Planning Committee B

- a) **Fulford Flood Alleviation Scheme, Pt Fulford (Pages 3 - 66)
Ings And Pt Playing Fields, Selby Road, York
[23/00283/FUL]**

Flood alleviation scheme comprising a pumping station and associated inlet structure, control kiosk, access track and parking area; culvert under Selby Road; outfall structure and floodwall alignment and penstock across Germany Beck; two earth flood embankments, and a temporary construction compound and tree works within the Fulford Conservation Area. [Fulford and Heslington Ward]

SHEET NUMBER
60651369-ACM-XX-XX-C-DR-1006

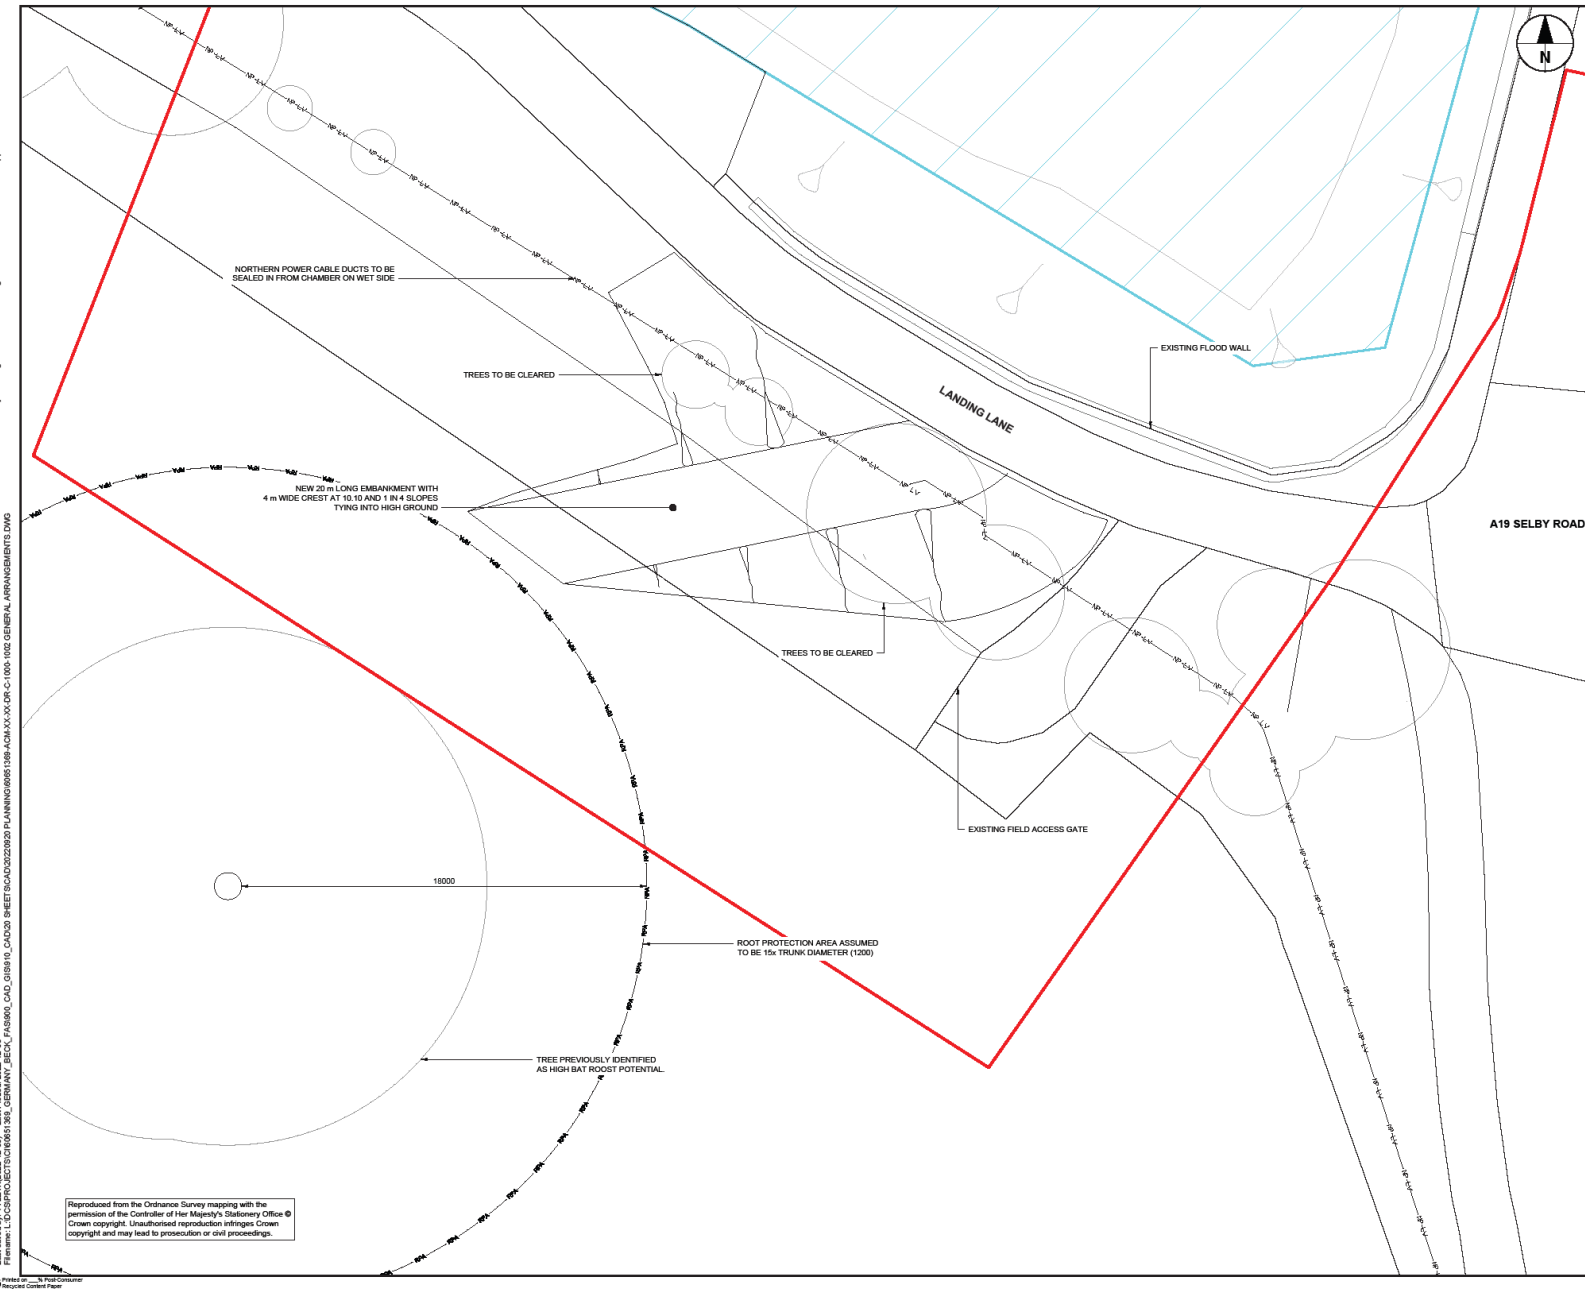
3.19 The drawing referenced 60651369-ACM-XX-XX-C-DR-1006 shows an activate penstock, if designed electronically there will need to be a contingency plan in place in case of a power failure.
